SEPTEMBER 27, 2018
REHABILITATION OF BRIDGE NO. 00255
I-395 OVER ROUTE 85
FEDERAL AID PROJECT NO. 0395(011)
STATE PROJECT NO. 152-158
TOWN OF WATERFORD

ADDENDUM NO. 1

APPENDIX A: Bearing Assembly Field Measurements

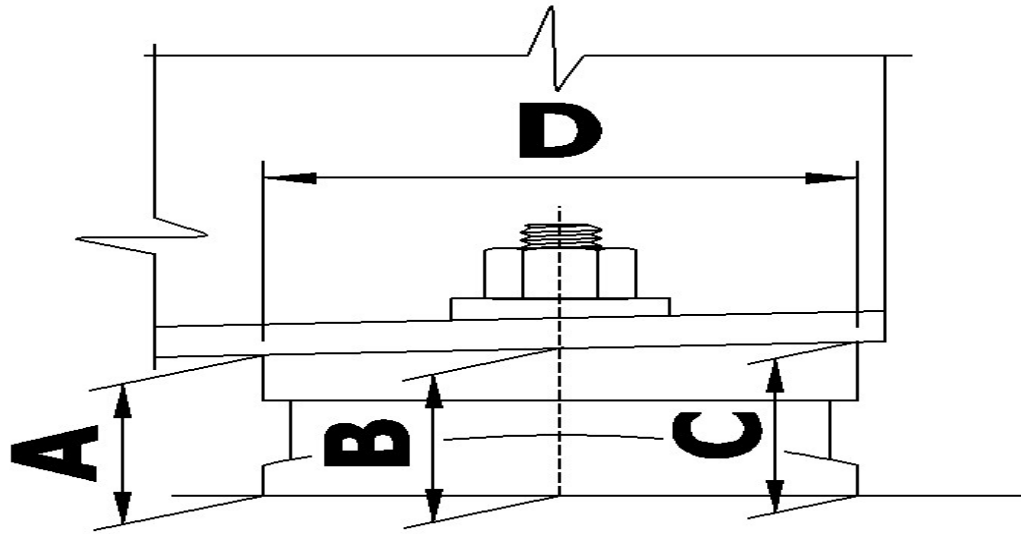
The Contractor shall measure the gap between the bottom of the existing girder flange and the top of the concrete surface at all bearing locations and obtain field measurements A, B and C (as illustrated in the sketch in this specification). Based on the field measurements and the proposed height of the bearing including the load plate, the Contractor shall calculate the actual thicknesses of the sole plates and submit the calculated sole plate thicknesses along with field measurements to the Engineer for review. The Contractor shall obtain the field measurements A, B & C at Girder G7 after lowering the Girder and determine the proposed

thicknesses of the sole plates. The calculated sole plate thicknesses shall be compared with the minimum sole plate thicknesses shown in the contract plans. The Contractor shall notify the Engineer prior to submitting shop drawings if after taking field measurements of the existing bearing assembly height, it is determined that the proposed sole plate thickness at the center line of bearing is less than 1.625 inches
